MSOX4034A-01

S E R V I C E N O T E

4000 X-Series Scopes

A replacement of the power supply cover is needed when the cabinet assembly is replaced.

New revision cabinet assembly (54709-64401)

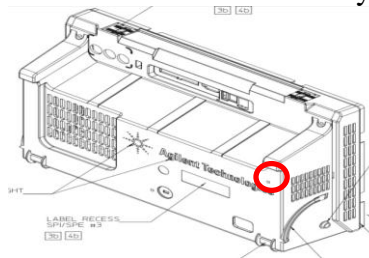
2. If the cabinet assembly is the new revision, proceed with repair as normal
3. If the cabinet assembly is the old revision
 - a. Replace the power supply cover (54695-00103) with new revision
 - b. Replace cabinet assembly as usual (54709-64401)
 - c. Insert screw (0515-0380) into the new screw hole on the cabinet assembly (circled below)
